# HISTORIC AND DESIGN REVIEW COMMISSION

**HDRC CASE NO:** 2024-349  
**ADDRESS:** 221 NEWELL  
**LEGAL DESCRIPTION:** NCB 14164 (SAMUELS GLASS MARKET (IDZ), BLOCK 1 LOT 24  
**ZONING:** IDZ, HL  
**CITY COUNCIL DIST.:** 1  
**LANDMARK:** Individual Landmark  
**APPLICANT:** Mesha Millsap  
**OWNER:** Rio Perla Properties, LP  
**TYPE OF WORK:** Historic Tax Verification  
**APPLICATION RECEIVED:** October 01, 2024  
**60-DAY REVIEW:** November 30, 2024  
**CASE MANAGER:** Rachel Rettaliata

The applicant is requesting Historic Tax Verification for the property at 221 Newell.

**SAMUELS GLASS BUILDING (Pearl Pullman Market)**

2 ENLARGED SECTION / ELEVATION - MAIN ENTRY - WEST  
1/4" = 1'-0"

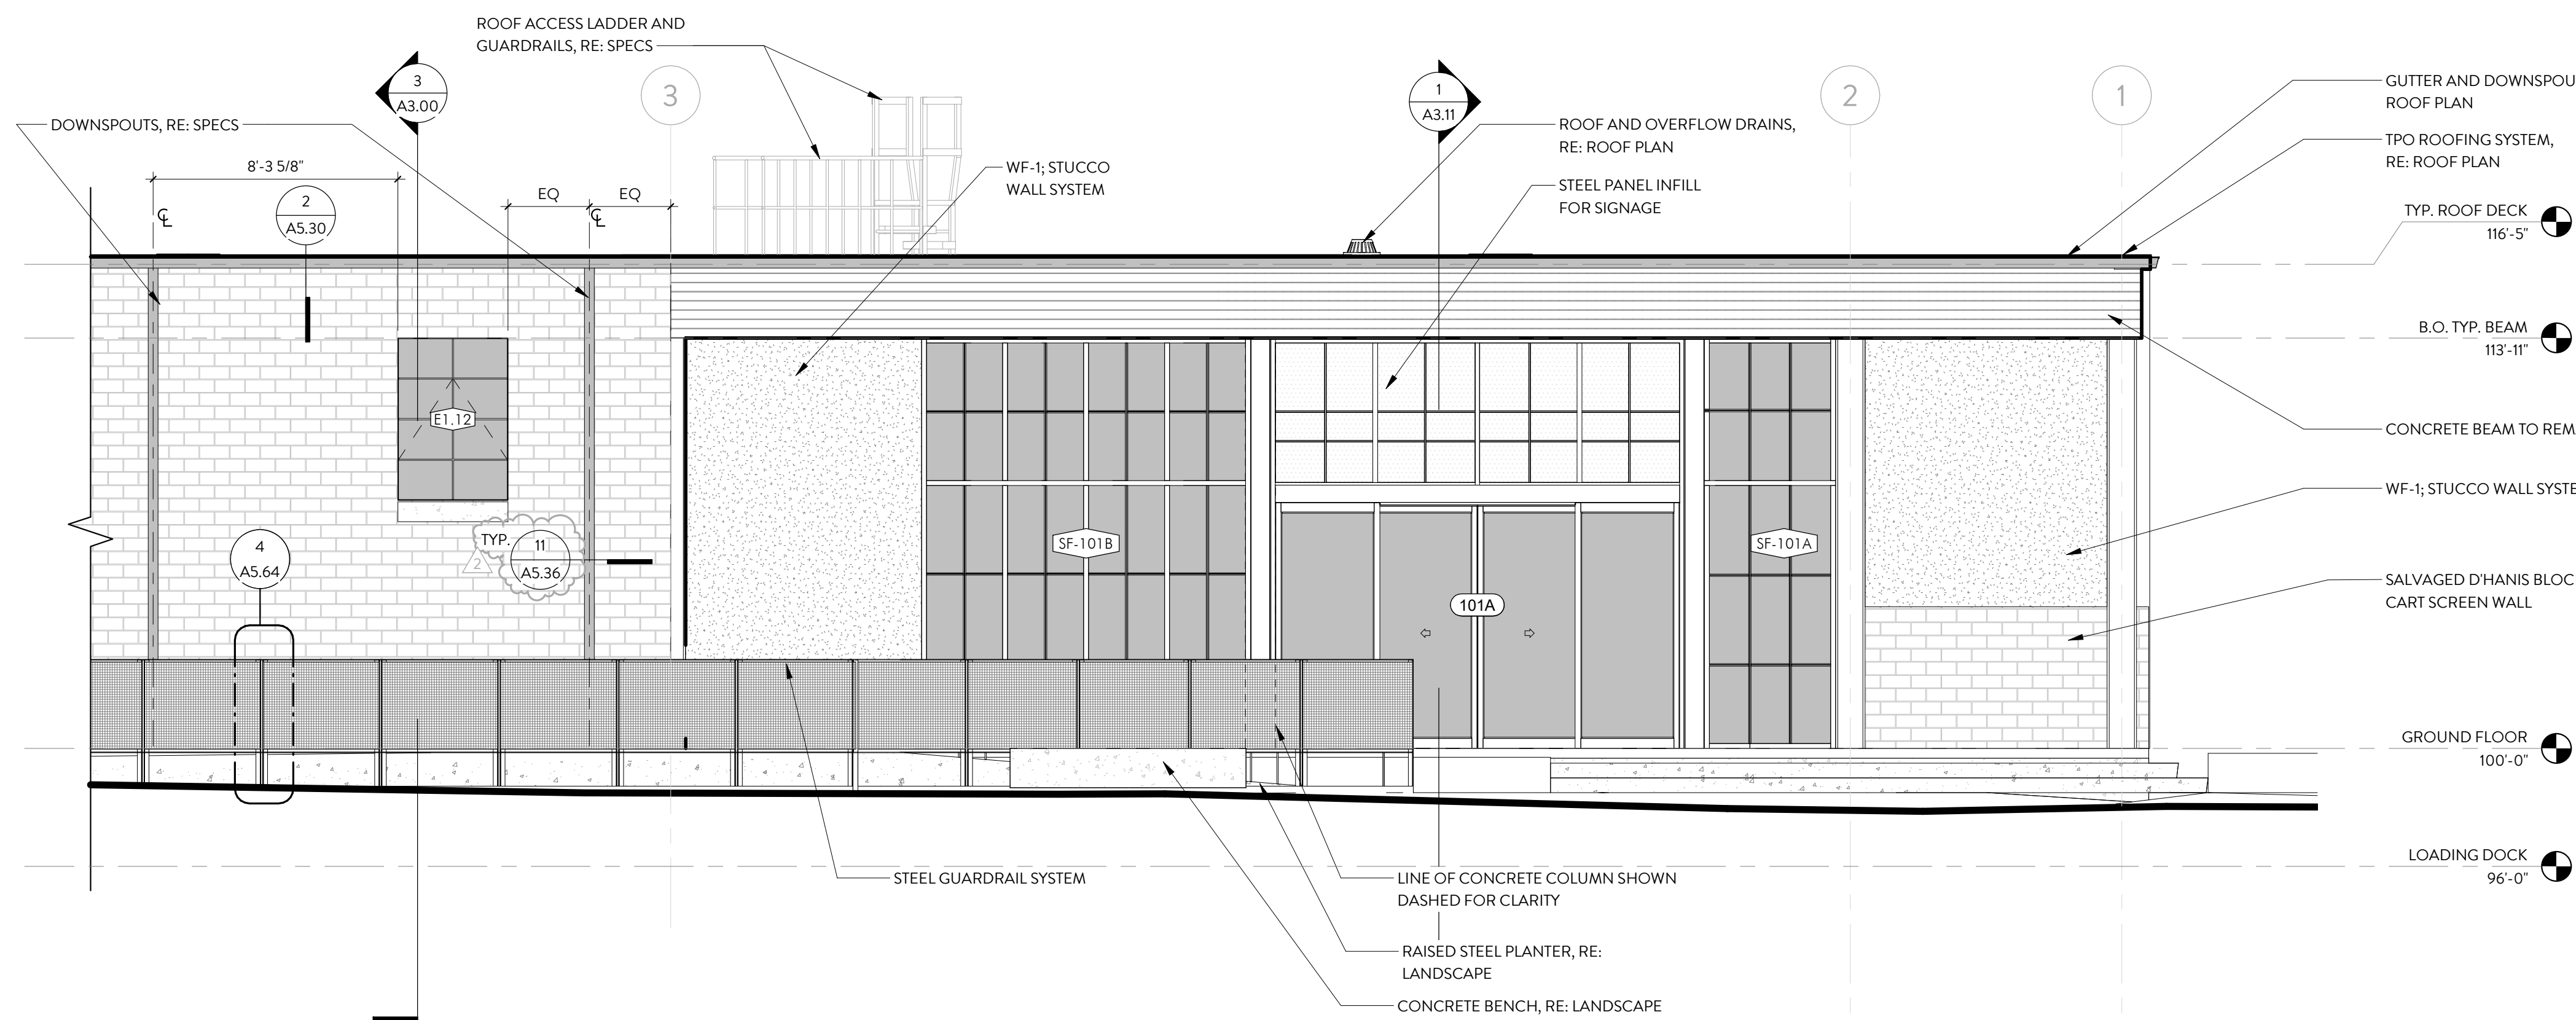
c. **FAÇADE MODIFICATIONS (South, Newell Façade)** – The applicant has proposed to perform façade modifications to the south (Newell) façade by expanding the existing loading dock, replacing the existing overhead rolling doors, low wall and steel windows with new overhead doors and a new aluminum storefront system, and create a larger entry vestibule. The Guidelines for Exterior Maintenance and Alterations 10.B.i. notes that new façade elements that alter or destroy the historic building character of a structure should not be introduced. Generally, staff finds that the proposed modifications are consistent with Guidelines as they maintain the industrial nature of the structure. Additionally, staff finds that all removed façade materials shall be salvaged for reuse.

2. Staff recommends approval of item #2, façade modifications to the south façade based on finding c with the following stipulations:

i. That all removed façade materials shall be salvaged for reuse.

ii. That detailed product specifications for the proposed storefront system are submitted to OHP staff for review and approval.

1 ENLARGED ELEVATION - KARNES MAIN ENTRY  
1/4" = 1'-0"

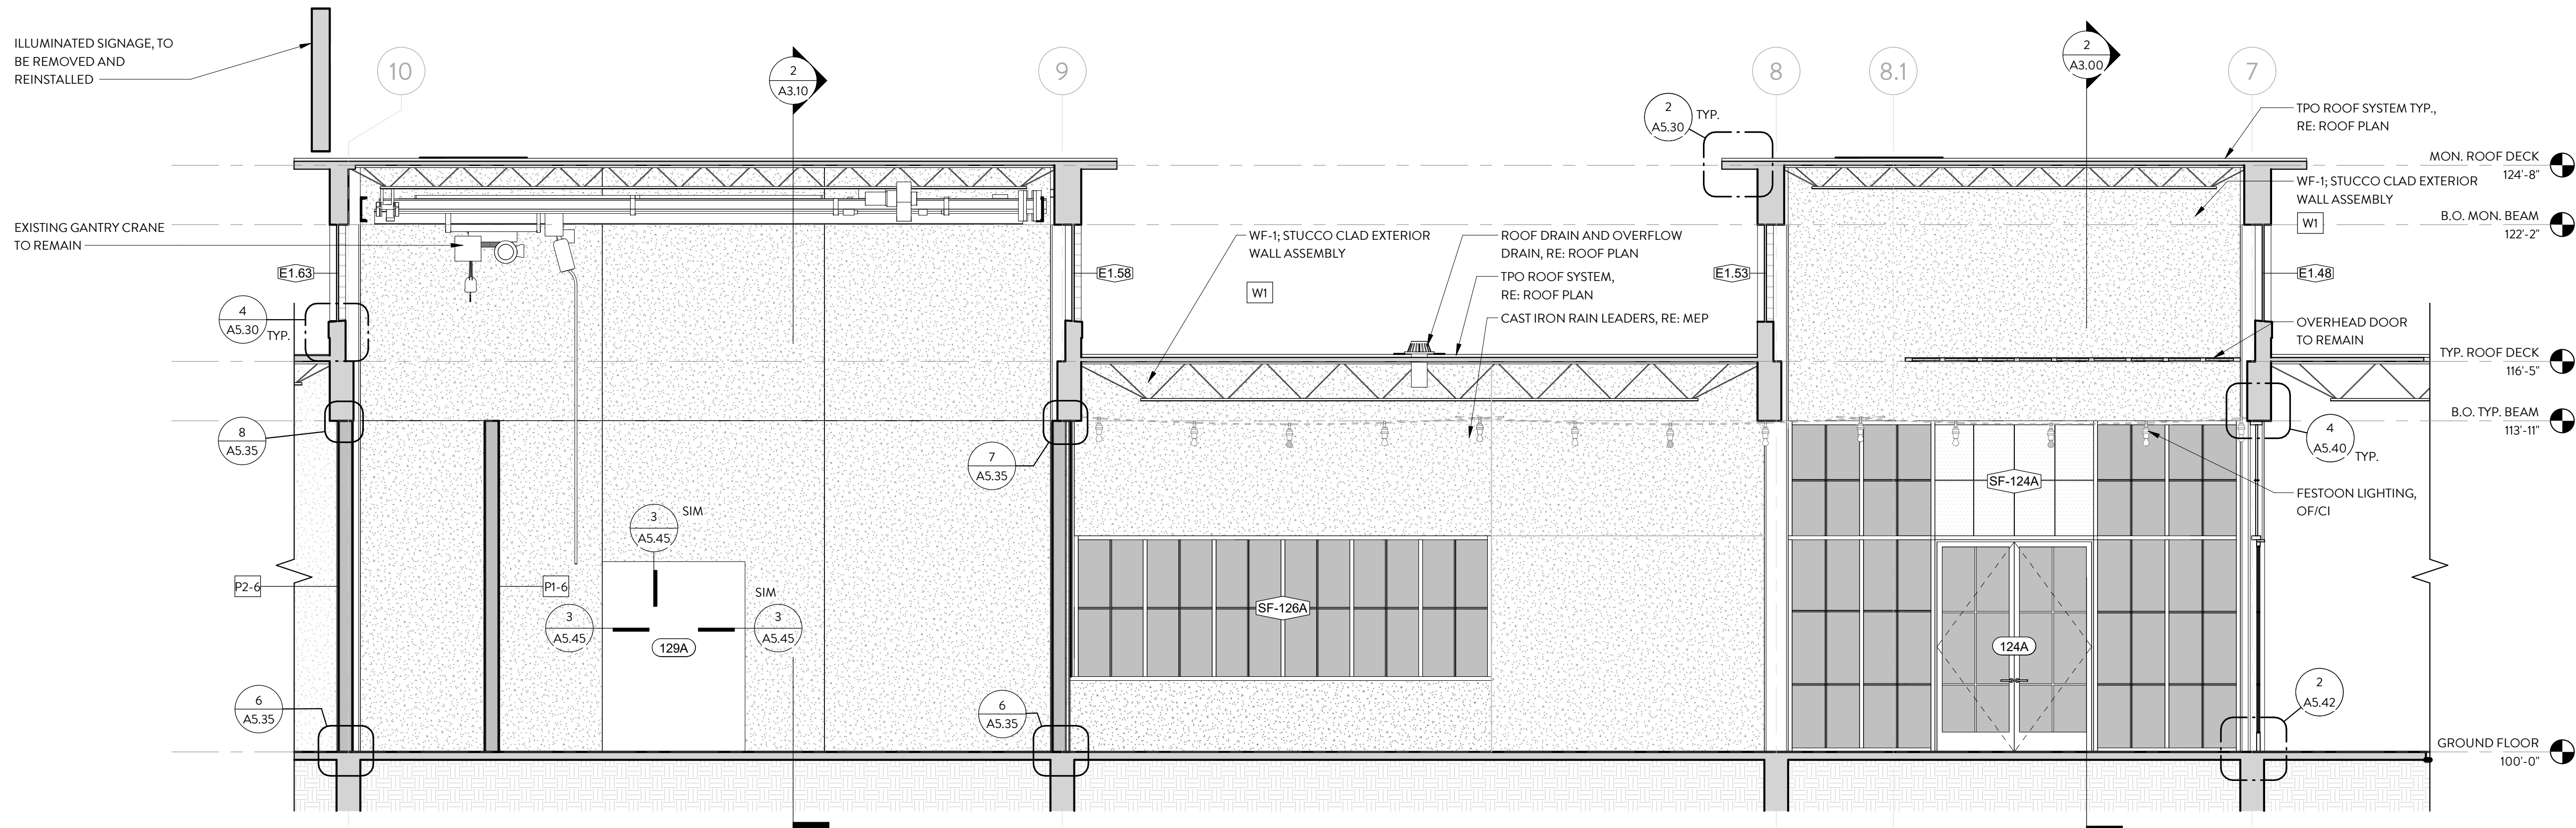
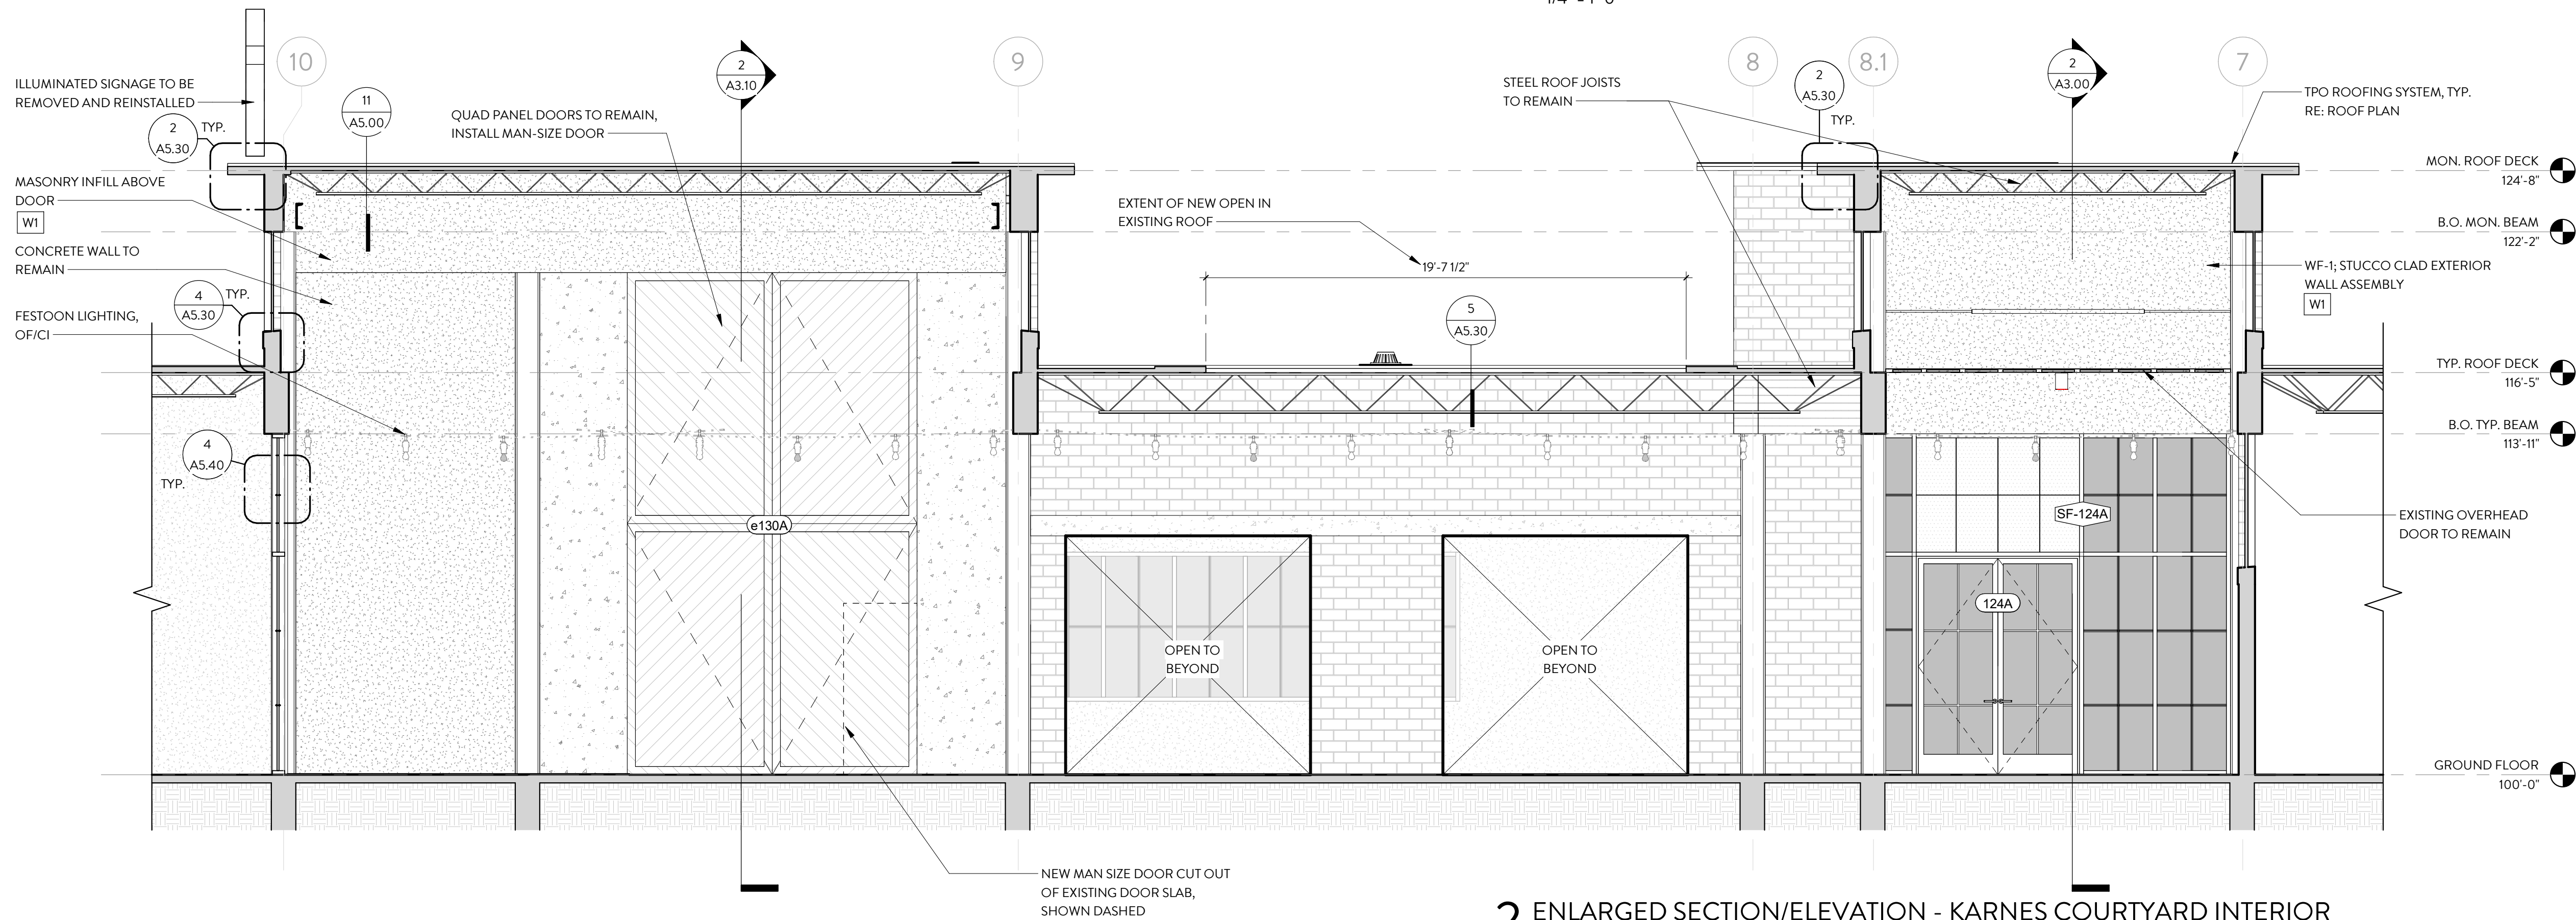
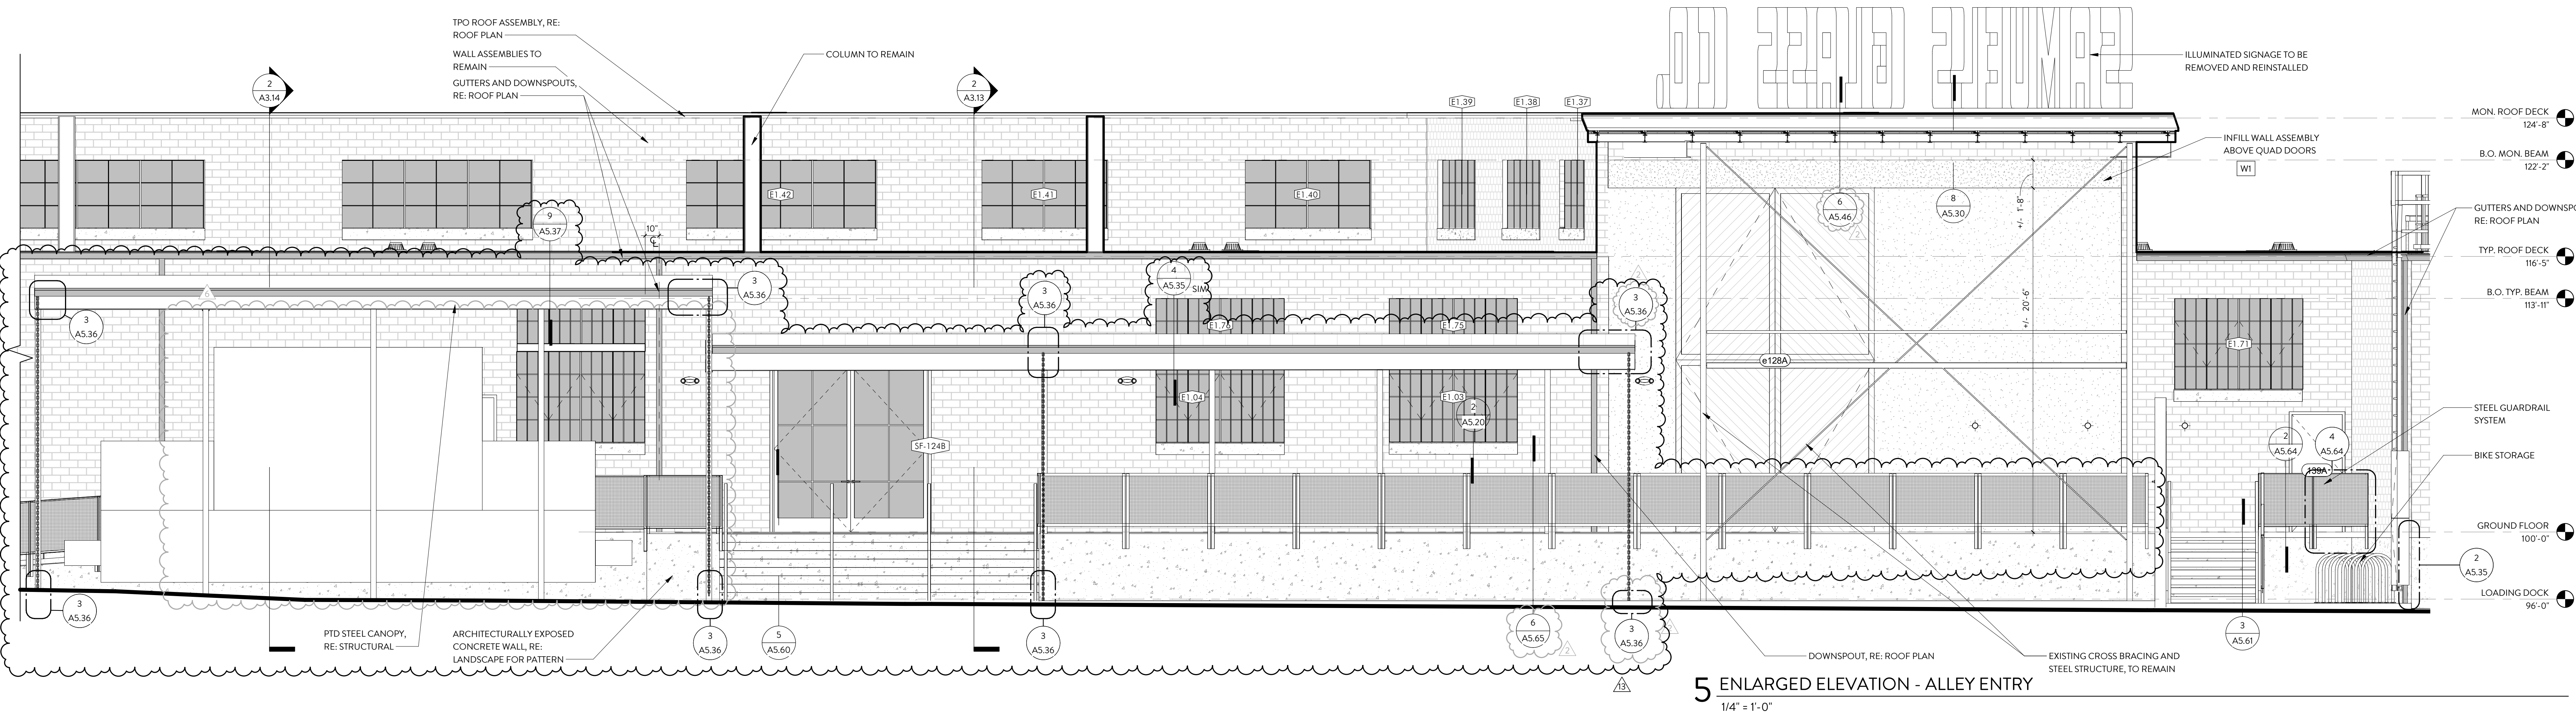
d. FAÇADE MODIFICATIONS (East, Karnes Façade) – The applicant has proposed to perform façade modifications to the east (Karnes) façade by creating several new entrances, replace an existing window with a new entry into a raised dining terrace, the installation of various raised terraces and a new canopied terrace. The existing east façade features three overhead rolling doors and industrially sized steel windows. The Guidelines for Exterior Maintenance and Alterations 10.B.i. notes that new façade elements that alter or destroy the historic building character of a structure should not be introduced. Staff finds the proposed modifications to the east façade generally maintain the existing profile and form of the original façade, while incorporating new elements. Staff finds the proposed modifications to be appropriate and consistent with the Guidelines. Additionally, staff finds that all removed façade materials shall be salvaged for reuse.

3. Staff recommends approval of item #3, façade modifications to the east façade based on finding d with the following stipulations:

i. That all removed façade materials shall be salvaged for reuse.

ii. That detailed product specifications for the proposed storefront system are submitted to OHP staff for review and approval.
